**Site Servicing and Stormwater  
Management Brief – Petrie's  
Landing III Block 8 Ottawa,  
ON**

September 21, 2021

**Appendix G CITY COMMENTS AND RESPONSE LETTER**

September 14, 2021  
File: 160401479 / D07-12-19-0212

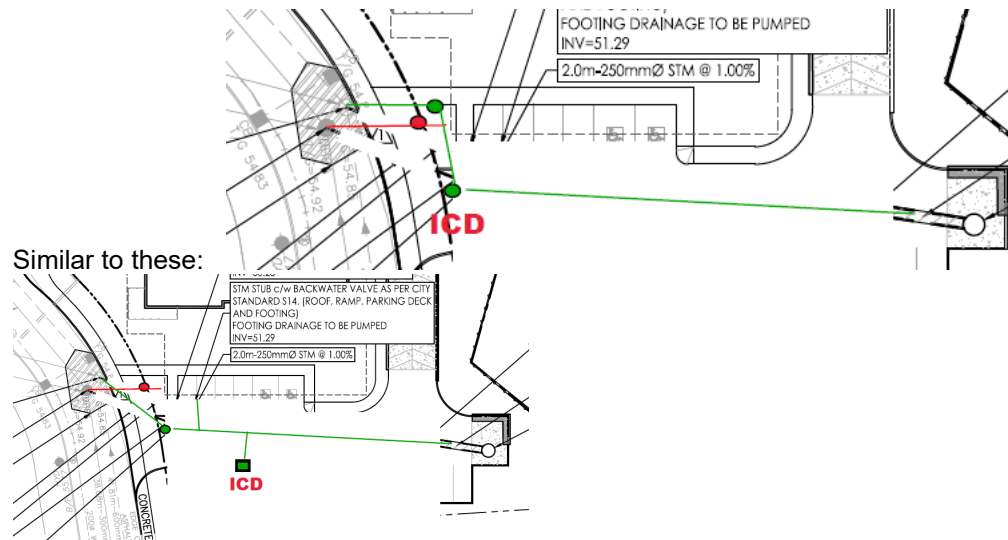
A12. RAMP: Your inside drainage may work if you have provided an oversized cistern. Not sure why you want to design this way when you could have a gravity outlet as per Sewer Detail S18 and S17. Reconsider please.

- **R/ Storm sewer elevations in the road are higher than the trench drain top of grate elevation. Pumping for some of the storm sewer system will be necessary. Trench drain to be designed to capture 100yr flows.**
